la marzocco USA technical bulletin 194

Linea Classic S new firmware v1.35

June 9, 2024

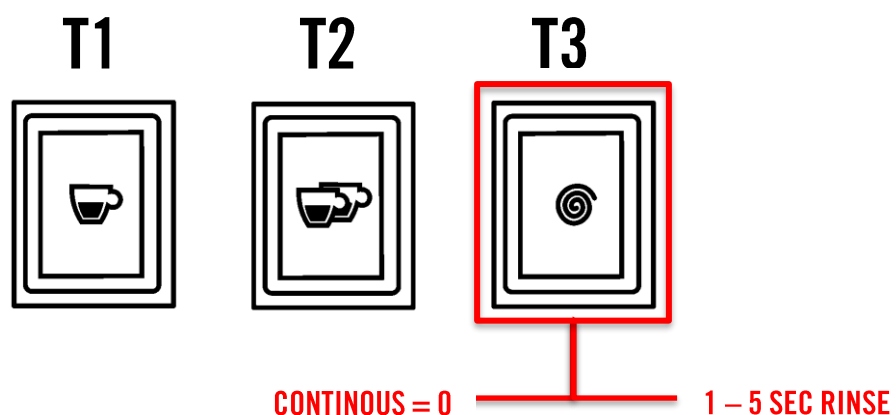
Firmware v1.35 fixes bugs and brings programmable rinse functionality to the third (continuous) button. In the barista menu, quick rinse can be set independently on each group for a duration of 1 to 5 seconds. Continuous is the default setting.

1. On Group 1 press and hold T3 (continuous) until the menu appears then release.
The display will show **PRG**.
2. Press T2 to advance to **GR5** and press T3 to enter.
3. Select a group using T2 to advance (**GR1** - group 1, **GR2** - group 2, **GR3** - group 3, **GR4** - group 4) press T3 to enter. Now you can select a value of 0 for continuous operation or 1 to 5 for quick rinse in seconds.
4. To Exit Barista Programming press T3 to advance to End and Press T3 again to return to normal operation
